**LEBANON PLANNING BOARD
DECEMBER 17, 2024 - 7:00 PM
COUNCIL CHAMBERS, CITY HALL OR
REMOTE VIA VIRTUAL PLATFORM
LEBANONNH.GOV/LIVE**

Re: The Brickyard Multi-family Planned Unit Residential Development (PURD)
174 Hanover Street Ext. & 238 Hanover Street (Map 48 Lots 1, 2, & 4 and Map 63 Lot 1)
Project Description and Impact Statement for Site Plan Review

Re: Proposed Multi-Family Development ("The Brickyard").
Site Plan Review Application
PUD/PURD Narrative Pieces

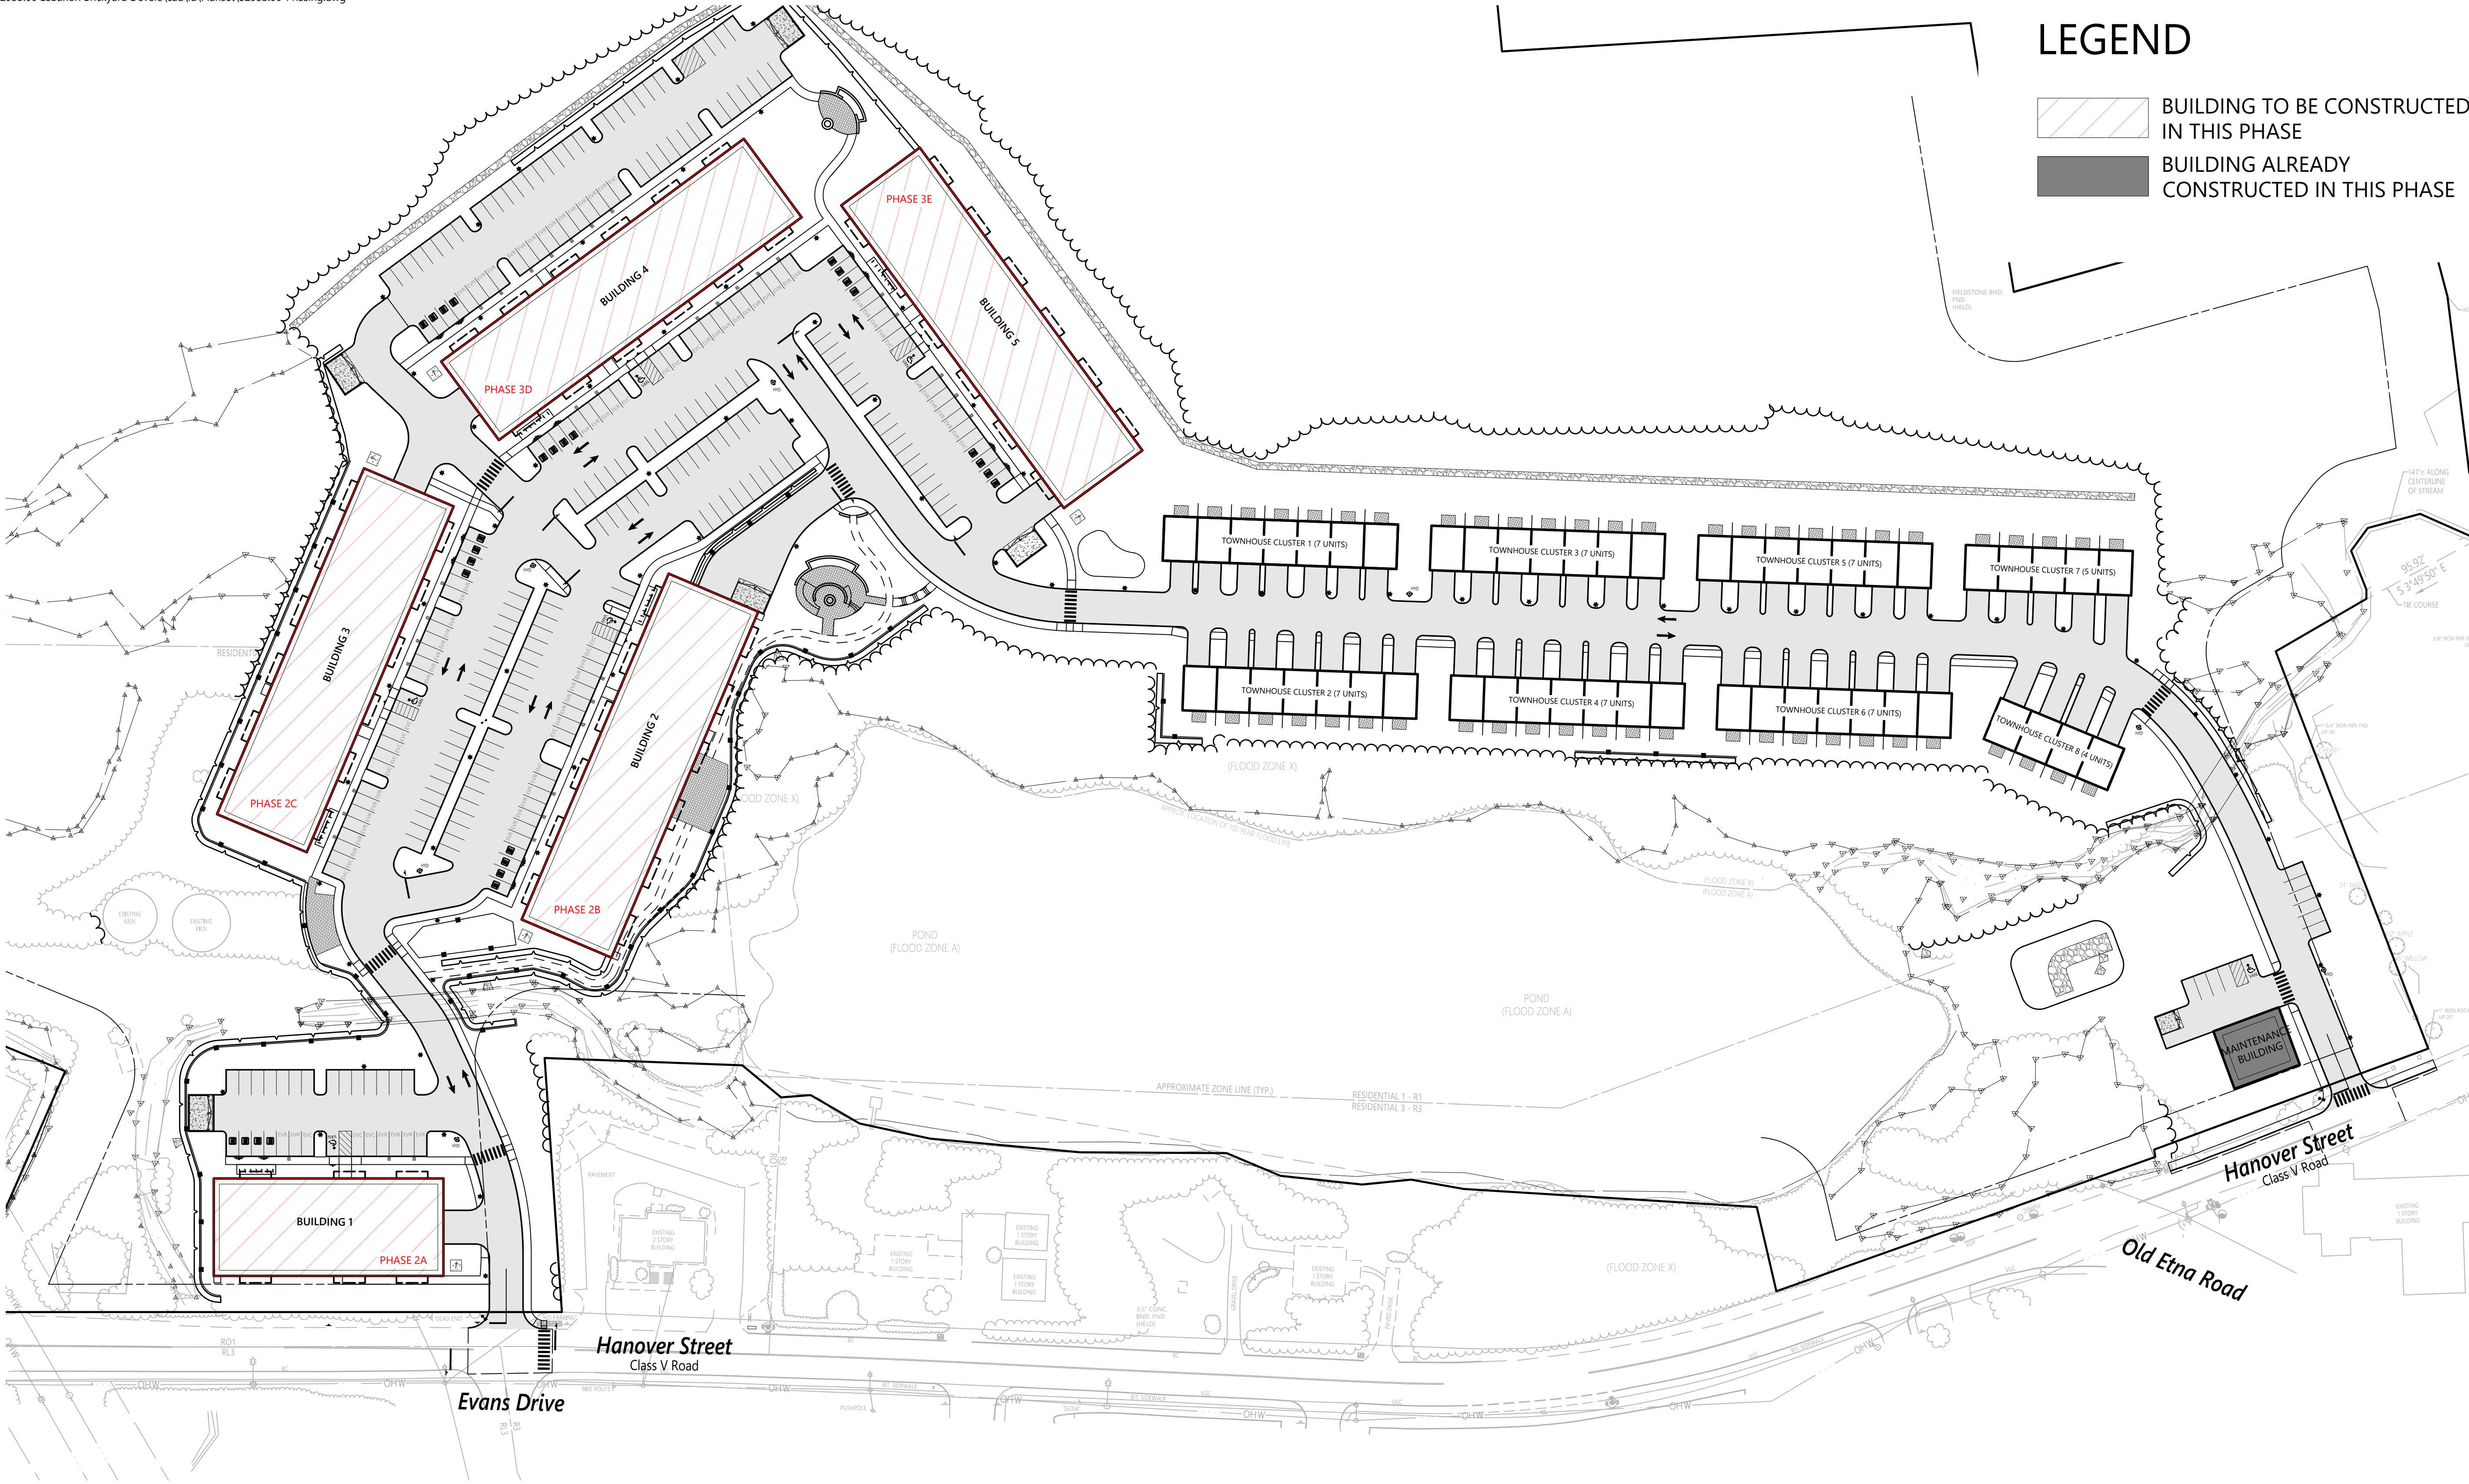
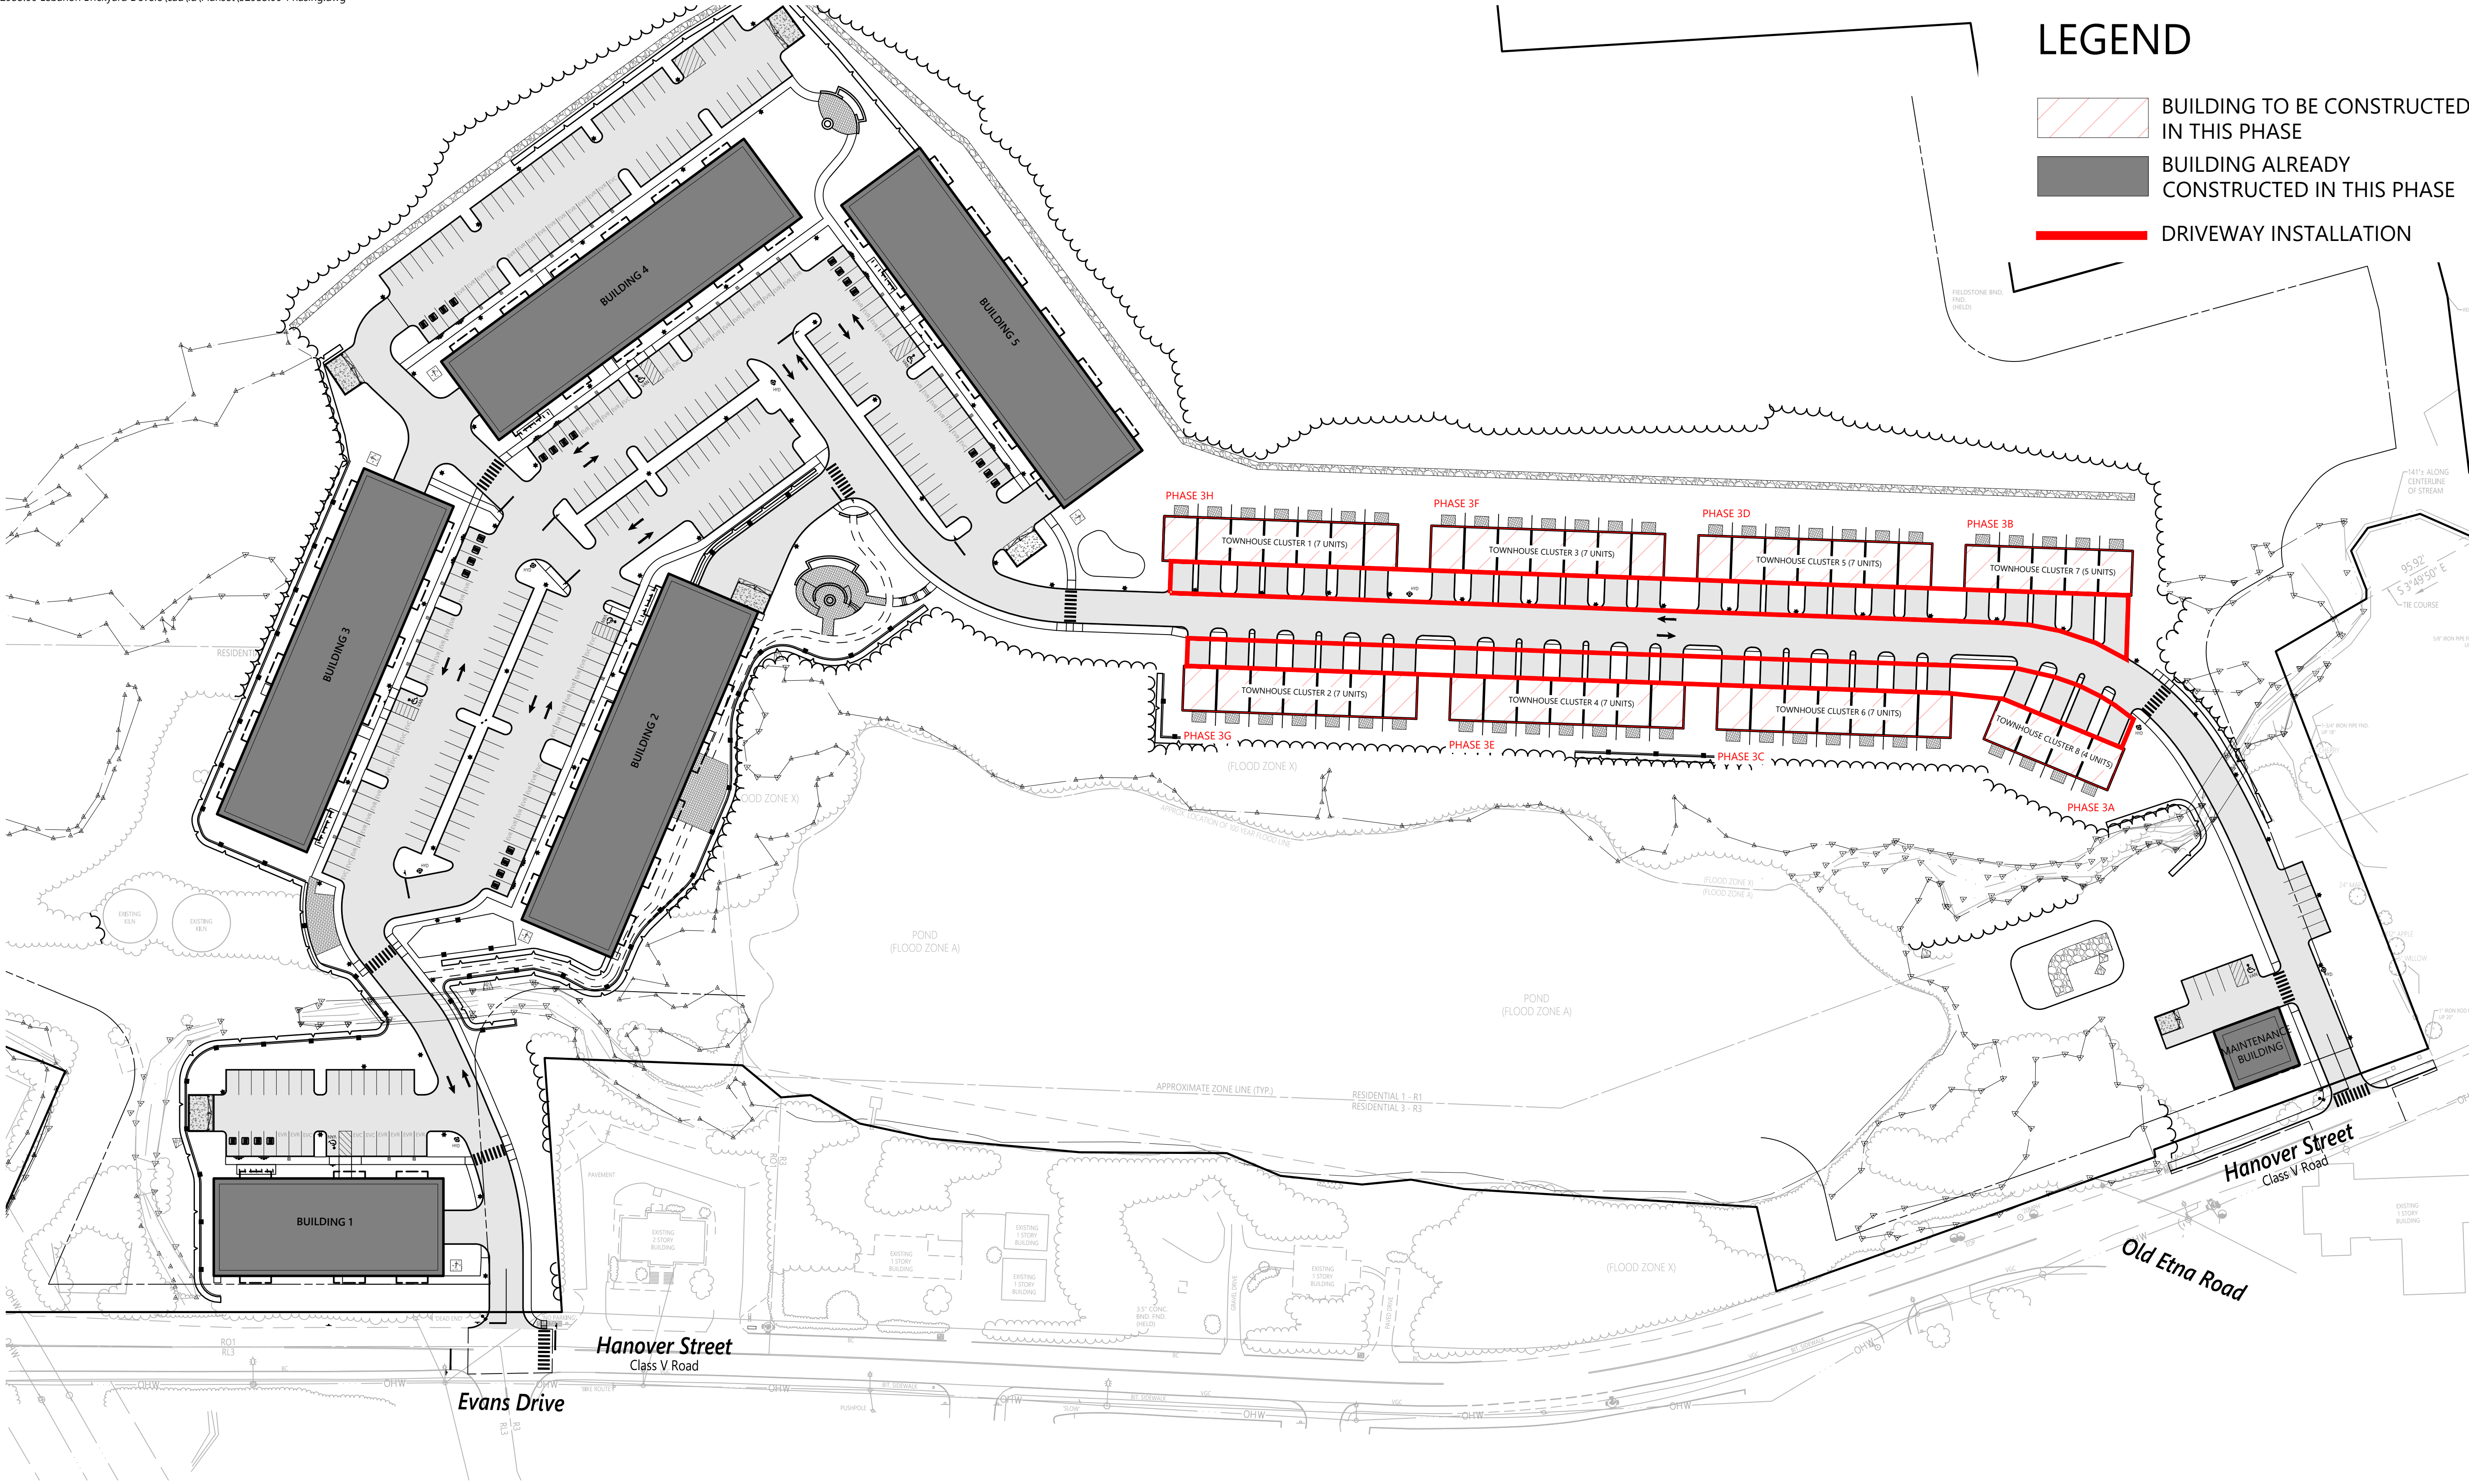
Comment 20. ***Phasing Plan - Sheets 30-33 (C8.1-4)***
